**NRDC Comments on ENERGY STAR's Final Draft Version 6.0**  
**Eligibility Criteria for Televisions**

Noah D. Horowitz  
Senior Scientist  
NRDC

July 24, 2012

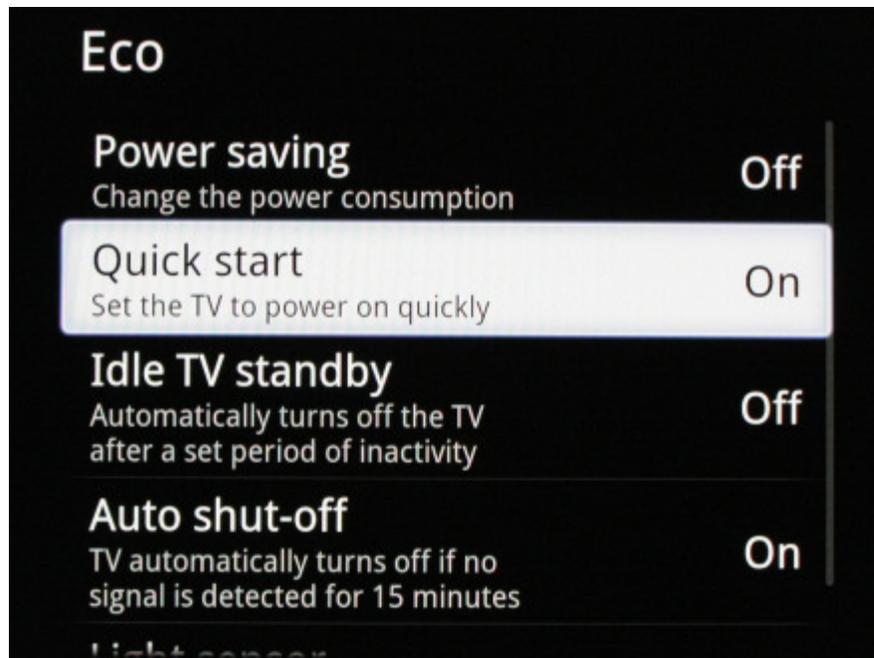
**1. Automatic Brightness Control** – NRDC acknowledges the timing challenges EPA faces between updating its specification on a timely basis vs. waiting for DOE to finalize its test method for TVs, in particular the portions that deal with Automatic Brightness Control. NRDC is supportive of the approach proposed by ENERGY STAR relative to Automatic Brightness Control. In particular, we support the ABC Sensor Validation Testing requirements contained in Section 4.3.1. These new requirements will prevent a manufacturer from gaming the system and “earning” the 10% incremental power allowance for TVs with ABC even though the sensor does not reduce power consumption in a meaningful way as ambient room light levels decrease.

Our two recommendations to further enhance the ABC requirements are:

- a. Should DOE's test method for TVs with ABC include a test point above 100 lux, then ESTAR should require that the measured on mode power at this brighter test point may not be less than the measured on mode power at 100 lux. We encourage EPA to include language adding this requirement to its specification.

b. ENERGY STAR should include language in the specification requiring manufacturers to report the discrete power levels measured at 10, 50, 100 lux ( and any additional points required by DOE) and this data will be published on ENERGY STAR's Qualified Product List (QPL).
